**PARTS & SERVICE
NEWS**

REF NO.	AT03013
DATE	Feb. 19, 2003

SUBJECT: REPAIR PROCEDURE OF JOYSTICK SWITCH ON WA700-3, WA800-3, WA900-3, WA1200-3

PURPOSE: To introduce modification procedure to repair malfunctioning of the F/R switch on the joystick (AJSS type) lever knob on WA1200-3, WA900-3, WA800-3 and WA700-3 wheel loaders

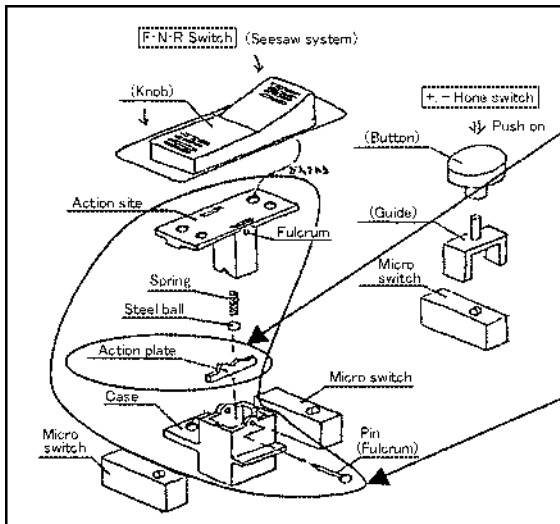
- 1) The detent section of the F/R seesaw switch on the AJSS type joystick lever knob on the WA1200-3, WA900-3, WA800-3 and WA700-3 wheel loaders may wear out to cause malfunctioning of returning to the "N" (neutral) position not staying at the "R" (or "F") position even after the switch is turned to the "R" (or "F") position.

As we have newly registered the internal parts to repair the above malfunctioning as spare parts, make the modification being introduced in this Service News by replacing these parts when the aforementioned malfunctioning occurs.

↓
Replacing new part:
CASE, DETENT (42C-S33-1160)

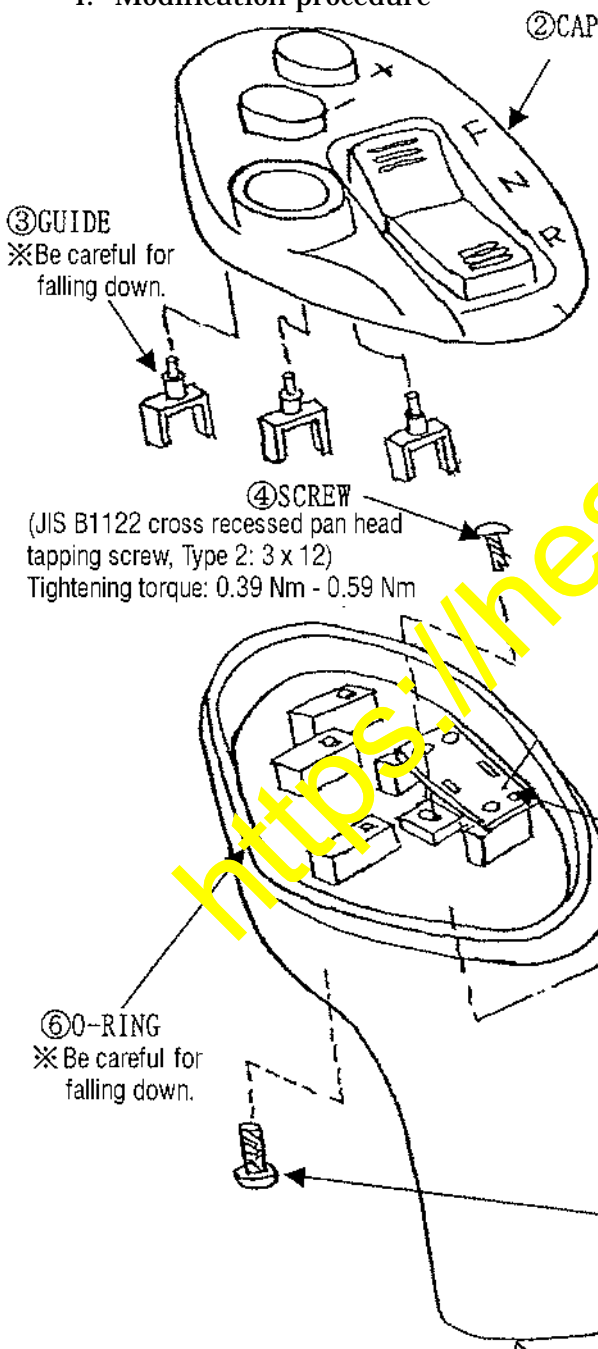
The surface hardness of the detent supporting action plate has been increased to improve the wear resistance.

- 3: Remove the screw ④ (1 pce.) and replace the current ⑤ CASE, DETENT with the newly registered CASE, DETENT (42C-S33-1160).
Tightening torque for the screw ④:

0.39 Nm - 0.59 Nm (0.04 kg·m - 0.06 kg·m)
- 4: Install the cap ② with the screws ①.
The O-ring ⑥ must be correctly positioned in the groove and not be dislocated or fall down.
Install the guides ③ (3 pcs.) in a position so that they step over the micro switches, respectively.
Tightening torque for the screw ①:

⑤ CASE, DETENT (42C-S33-1160)
Replace with the newly registered CASE, DETENT.

① SCREW
(JIS B1122 cross recessed pan head tapping screw, Type 2: 4 x 16)
Tightening torque: 0.78 Nm - 0.98 Nm
